RESPONSE TO REQUEST FOR ADDITIONAL INFORMATION

US-APWR Design Certification

Docket No.52-021

RAI NO.: NO.589-4536 REVISION 2
SRP SECTION: 03.11 – Environmental Qualification of Mechanical and Electrical Equipment
APPLICATION SECTION: 3.11
DATE OF RAI ISSUE: 6/8/2010

Figure 1 Calculation Flow for Estimating the Accident Dose Rate Inside Containment

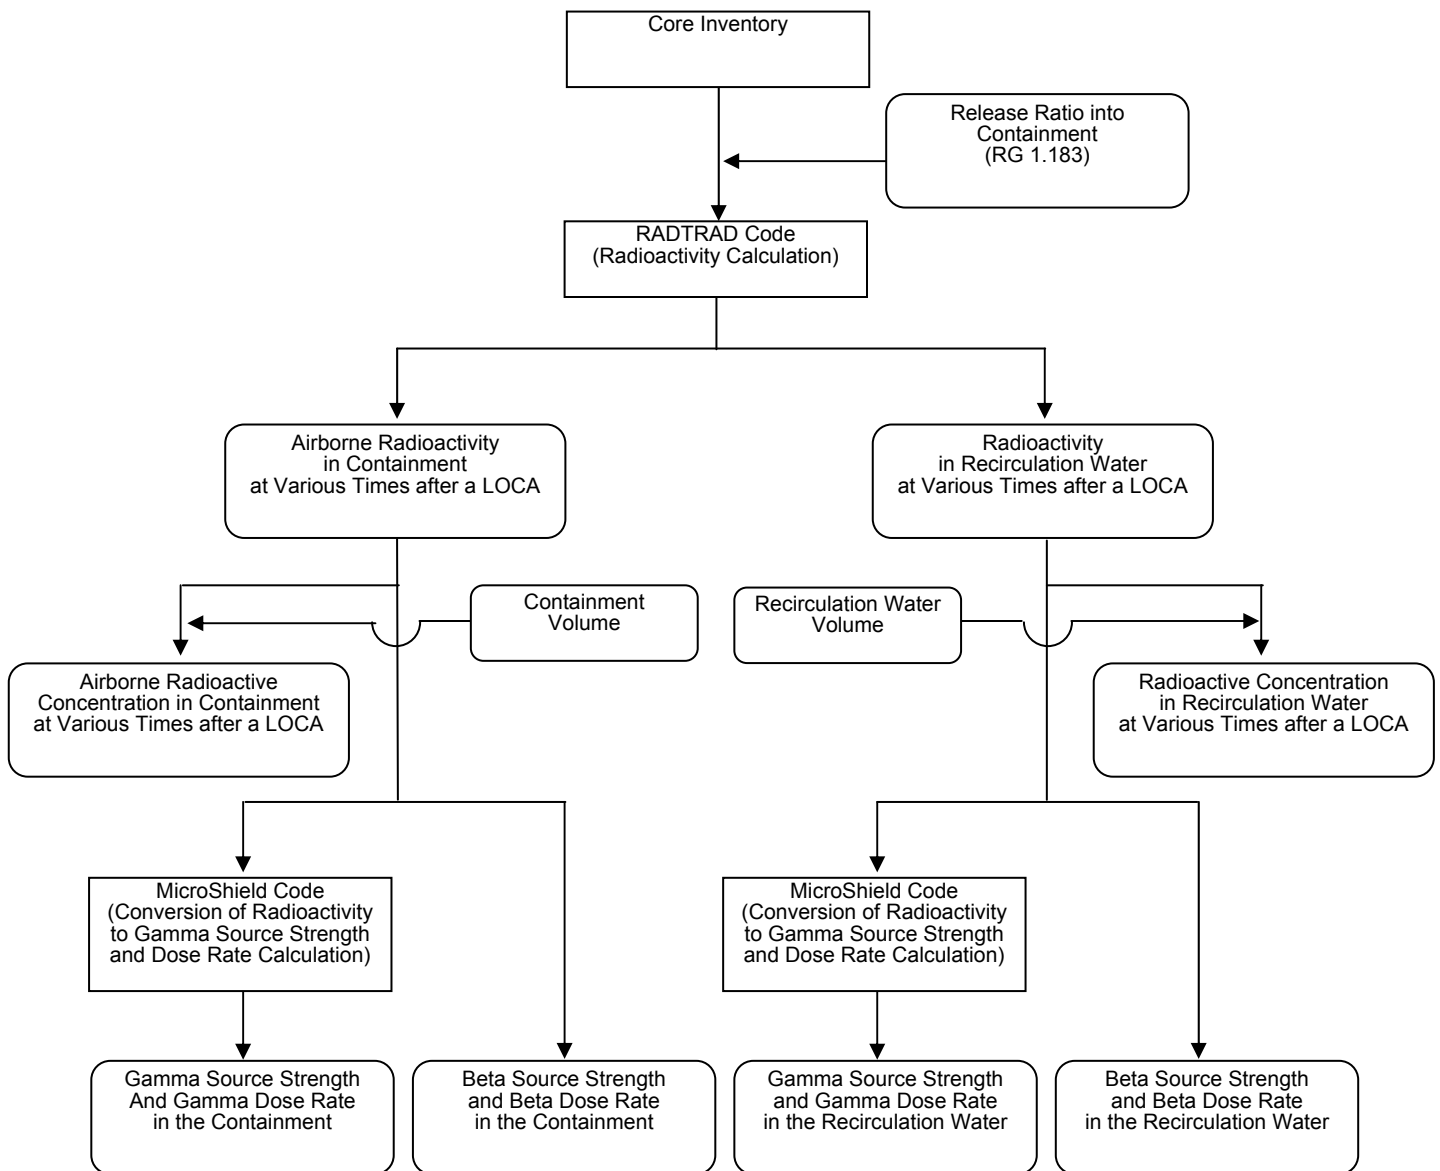
- Describe any computer codes, including revisions, besides MicroShield, that were used to calculate dose rates and the resultant Total Integrated Dose (TID) to equipment,
- Provide a sample calculation performed by the applicant to calculated dose rates and the resultant TID resulting from liquids, plated out material and airborne activity, including the input parameter and output data files of MicroShield and any other computer codes used for the analysis.
- Describe the basis for any assumed parameters, such as the Geometry Correction Factor, or the type of surface selected to represent a plate outsource.

- Describe the methods for averaging dose rate to obtain TID for the stated intervals, and for interpolating the Source Strength at Time after Release provided in Table 1, and the Operational Durations specified in MUAP-08015(R1) Table 5-5.
- Revise and update either MUAP-08015 Revision 1 or FSAR Revision 2 Tier 2 Section 3.11 to include a complete description of the methods and assumptions, and referenced documents, used to calculate equipment TID.

MUAP-08015 Revision 1, Table 5-5 "Total Integrated Dose for Zone" provides a summary of the cumulative normal and accident doses used to determine the total integrated dose (TID) for each Environmental Zone of the US-APWR. In accordance with the previously provided response to RAI 358-2462 Revision 1 Question 03.11-2 Item 5, the cumulative accident dose listed in Table 5-5 for each Environmental Zone, excluding the containment, annulus, and main steam piping area outside containment (i.e., Zones 2-5, 7-9, and 11-14), is calculated using the upper limit dose rate of any location within the respective Environmental Zone shown in Figures 12.3-3 through 12.3-6 of US-APWR DCD Section 12.3.

The calculation method for the cumulative accident dose of the containment, annulus, and main steam piping area (Zones 1, 6, and 10) was previously provided in MHI's responses to RAI 358-2642 Revision 1 Question 03.11-2 Item 5 (ML091970103), RAI 358-2642 Revision 1 Question 03.11-1 Item 1, and RAI 512-3893 Question 03.11-29 (ML100330613). The resulting cumulative accident dose was then used in MUAP-08015 Revision 1. However, the resultant cumulative doses are too conservative for actual equipment procurement. Therefore, MHI has opted to perform a more realistic dose estimation to reduce the cumulative dose in containment. This revised response explains the changes incorporated into the updated accident dose calculation as follows.

MHI reduces the cumulative doses inside containment provided in technical report MUAP-08015 Revision 1 by reducing the level of conservatism included in the calculation assumptions. The level of conservatism used in the updated calculation is closer to that typically used in the U.S. nuclear industry, making procurement of equipment easier.

The assumed conditions associated with the doses included in MUAP-08015 Revision 1 are highly conservative as described in the previous responses to RAIs 358 and 512. In order to reduce the cumulative doses inside containment, only the assumptions summarized in Table 1 are changed. The dose calculation method is not changed from that of MUAP-08015 Revision 1.

These changes are implemented with using the DCD Chapter 15 dose analysis code RADTRAD. The revised calculation conditions are same as those used in DCD Chapter 15, except for (1) the evaluation time after accident occurrence, (2) no consideration of radioactivity leakage, and (3) no consideration of plate-out. Additional details regarding these calculation condition differences are described in Section 2 of this response. The calculation flow for evaluating the accident dose rate inside containment is shown in Figure 1. In addition, the electronic data (including MicroShield input data, MicroShield output data and Microsoft EXCEL spreadsheets) that is used for the TID calculation is provided in order to facilitate the confirmation of the calculated TID by the NRC staff.
